LAND WEST OF TYE LANE, WALBERTON

HIGHWAYS RESPONSE NOTE

December 2020

David Wilson Homes

Figure 2: Development Flows on Fontwell East Roundabout

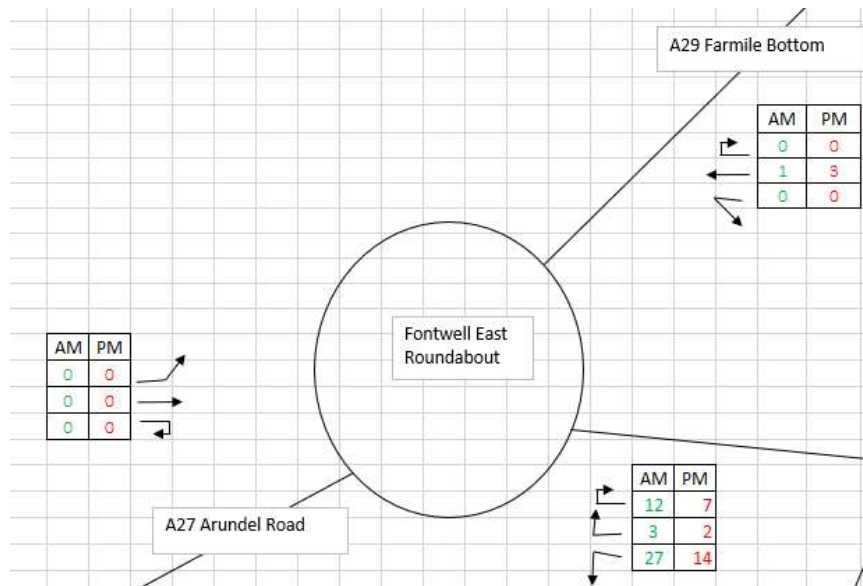
- 3.2 The highway comments received from both WSCC and HE, however, have requested that junction capacity assessments are undertaken for both roundabouts to fully determine the likely impact of the proposed development on their operation. Discussions with WSCC have been undertaken to determine the model that is considered to be the most robust and 'up-to-date' in order for these assessments to be undertaken. The following scenarios are therefore those used within our assessment:

- 3.10 **Table 1** demonstrates that the impact of the proposed development is minimal, with the worst performing arm in the AM deteriorates from a DoS of 88.2% to 89.2% with the development and in the PM the worst performing arm deteriorates from 84.6% 85.8% with the development, both of which have an insignificant impact on the delay and queuing of vehicles.

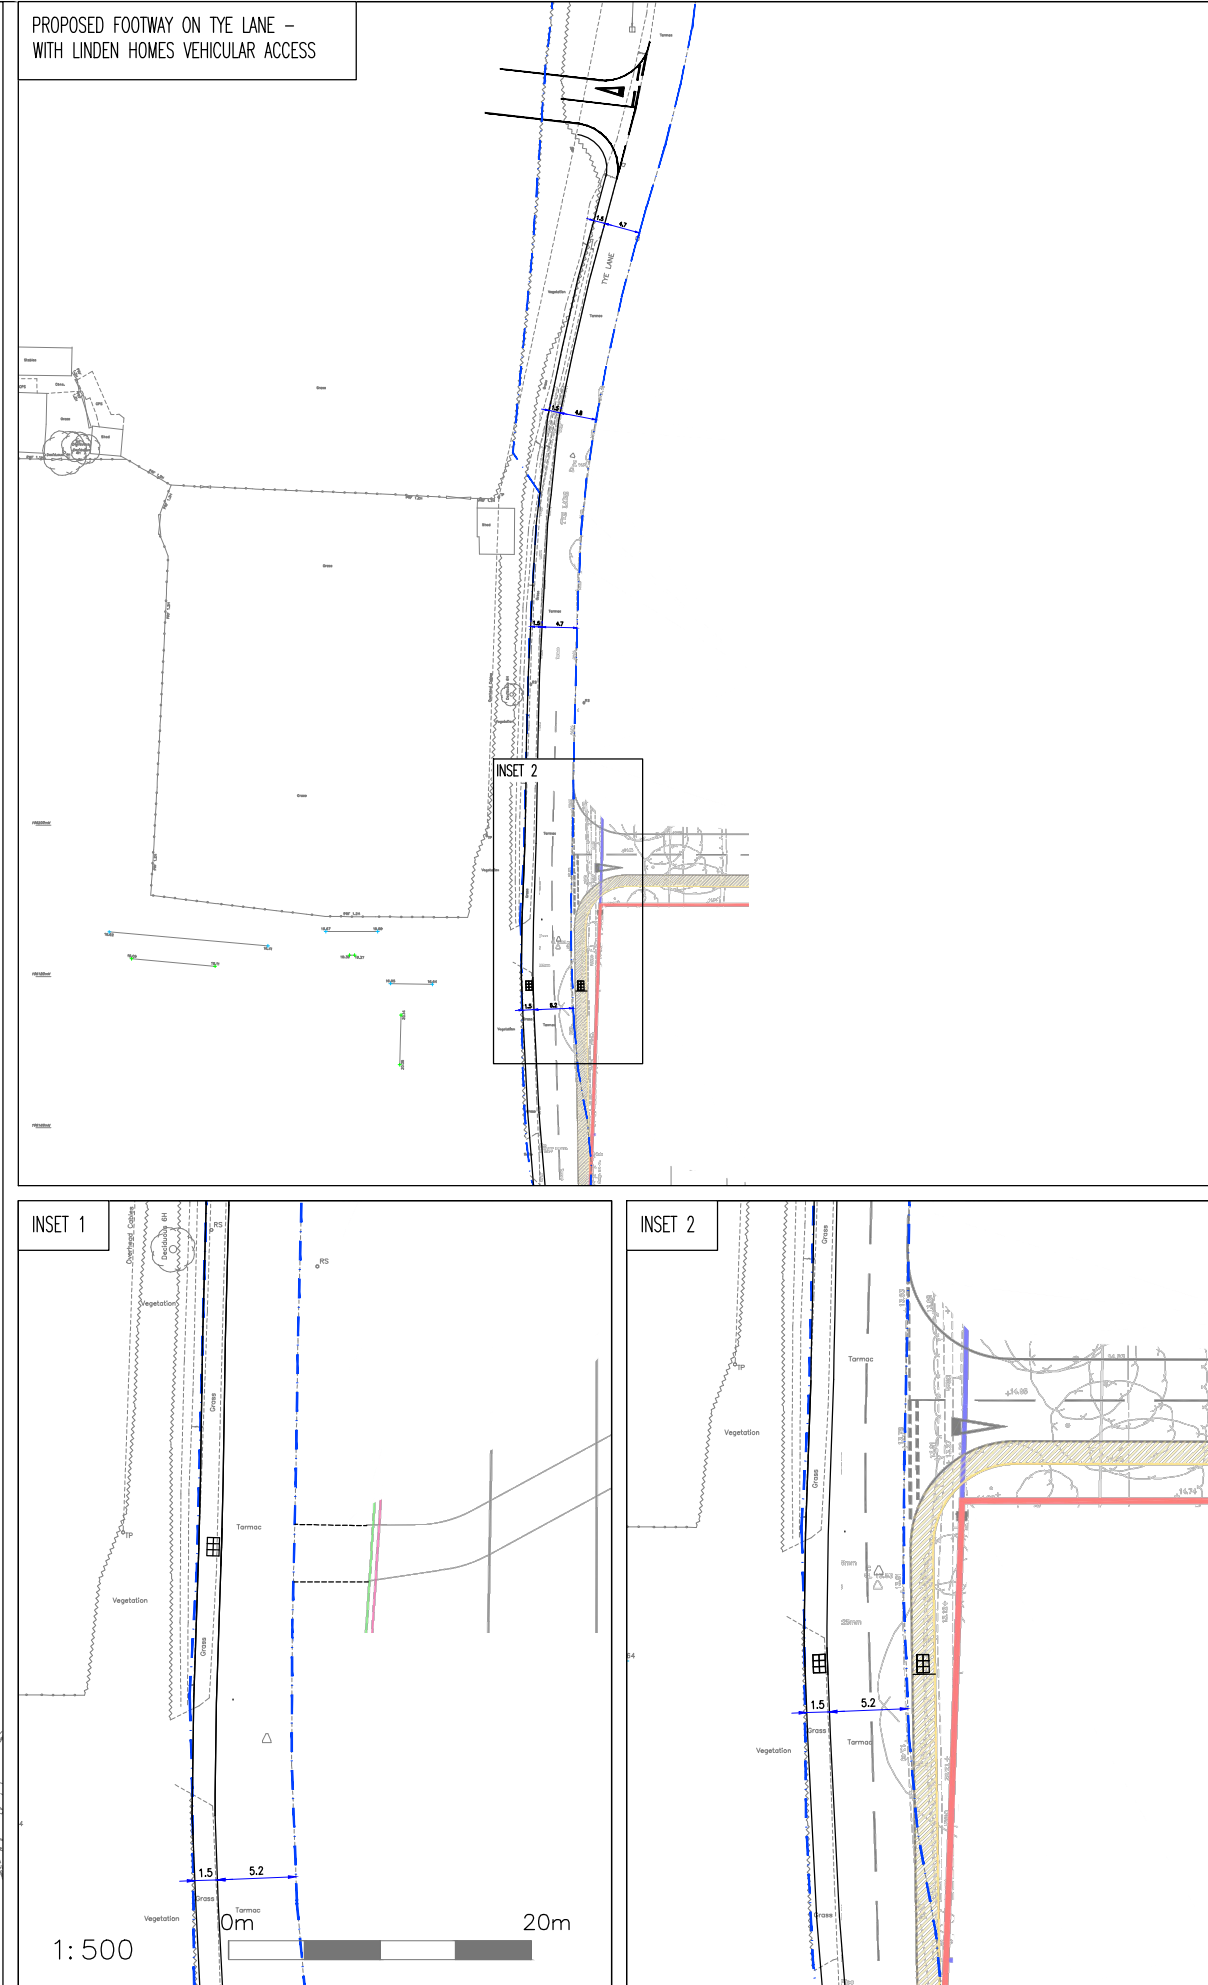
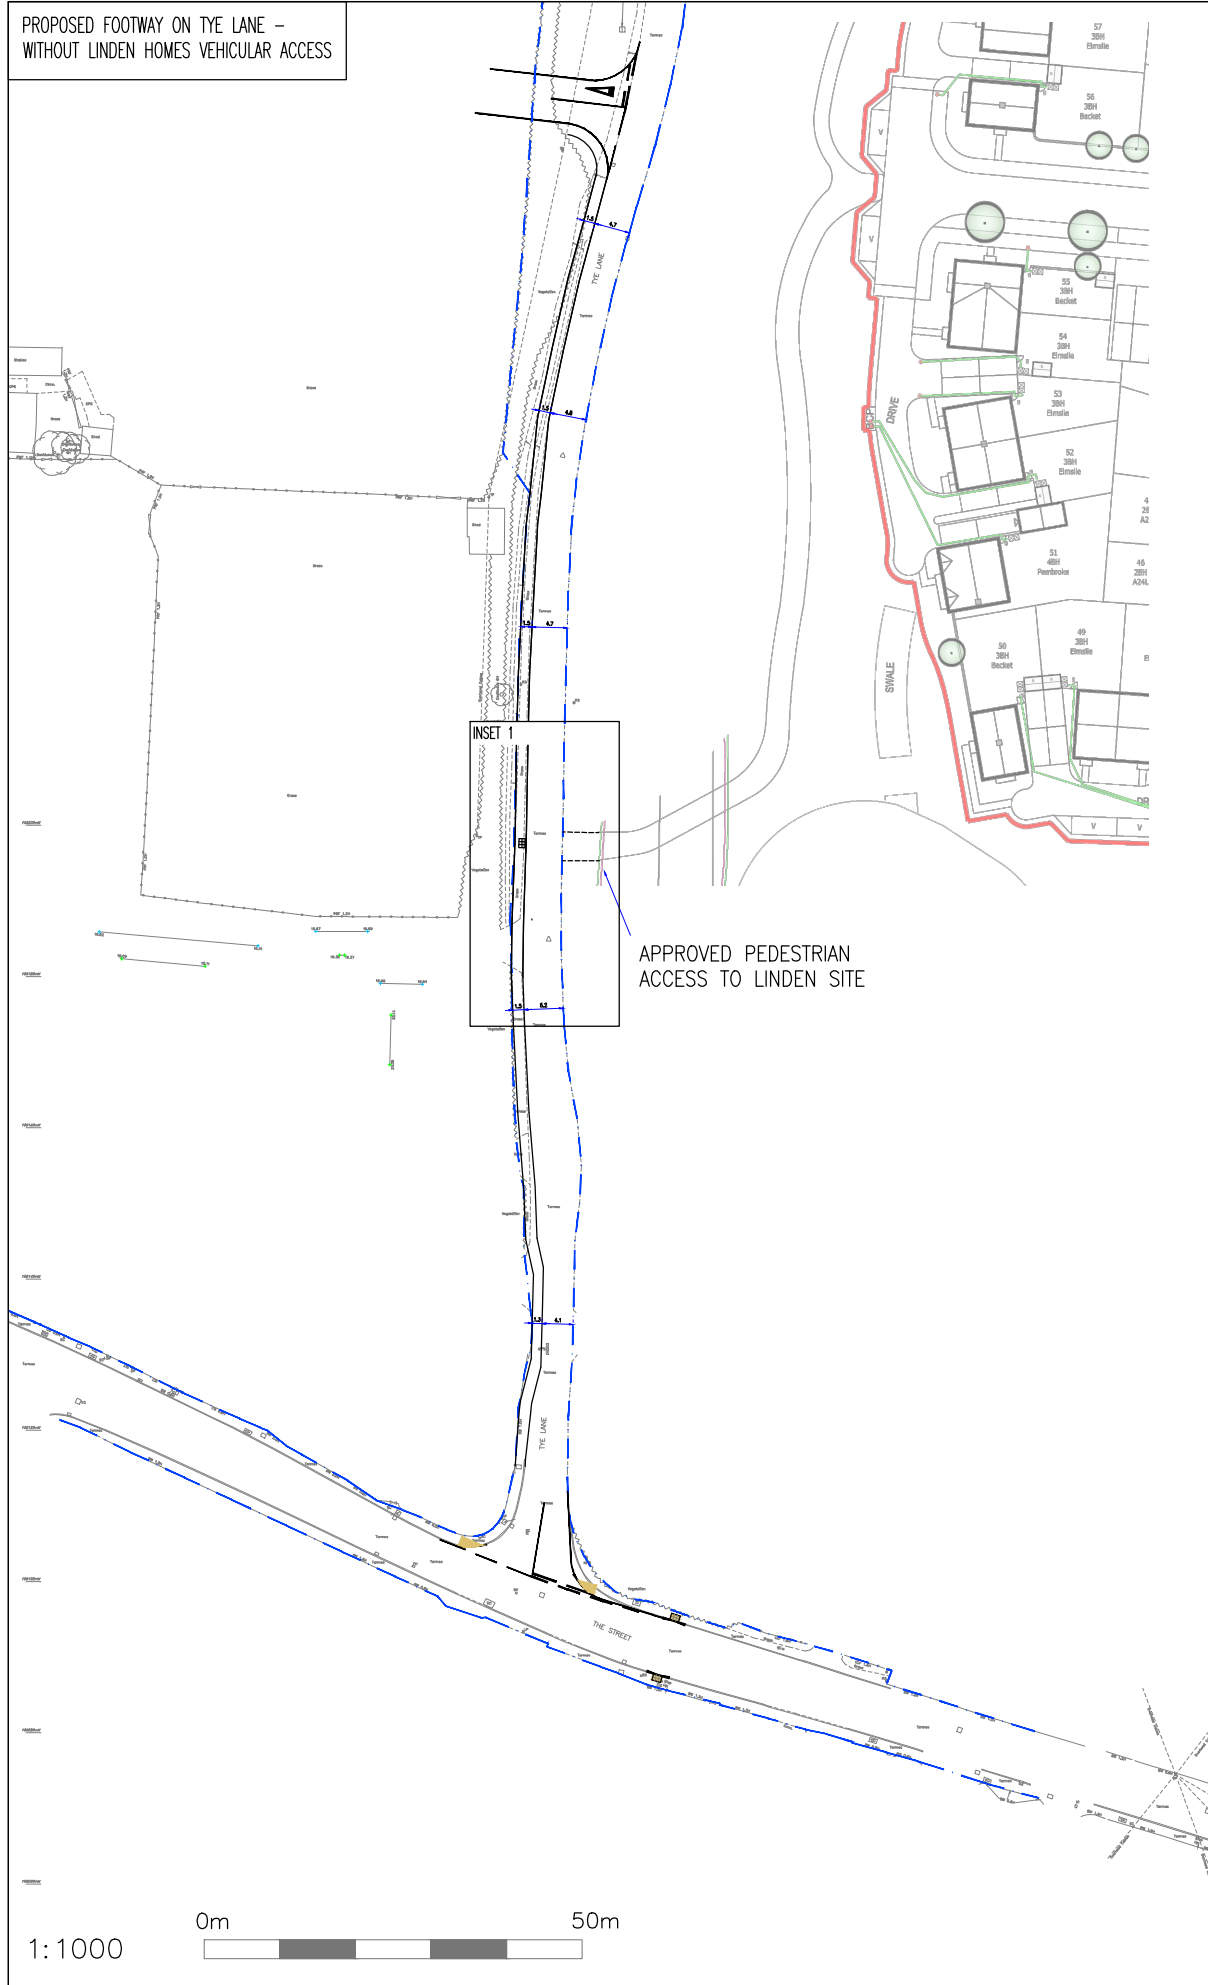
- 2.2 The highway comments received from WSCC detailed their preference for a footway to accompany the vehicular access along Tye Lane, continuing south and connecting into The Street.

- 2.4 Having considered WSCC's comments, a footway design has been prepared which routes along the western edge of Tye Lane. The proposed footway maintains a 1.5m footway between the Land West of Tye Lane vehicular access and The Street. This footway proposes two alternative options to connect into the footway accompanying the Linden Homes site, depending on whether they construct the consented pedestrian only access or the currently proposed vehicular access onto Tye Lane. The arrangement for this footway, together with the two connection options, is shown at **Appendix C**.

- 2.5 As can be seen from the drawing at **Appendix C**, the footway measures a consistent 1.5m along its entire length, between the vehicular access to the north and The Street to the south, connecting into the existing section of footway along Tye Lane to the southern extent. As a result, the carriageway width is restricted in places to between 4.8-5.0m. The carriageway width of Tye Lane is currently c. 5m so this narrowing only takes place in certain places and is considered appropriate given the current characteristics of Tye Lane.

- 2.6 The only anomaly to the above is where, due to restricted land availability, the carriageway is reduced to a width of 4.1m (still sufficient for 2 cars to pass according to Manual for Streets) and as a result the footway is reduced to 1.3m. This narrowing takes place over a distance of c.10m towards the south of Tye Lane and is considered necessary to provide a footway of acceptable width whilst maintaining a carriageway width suitable for two cars to pass.
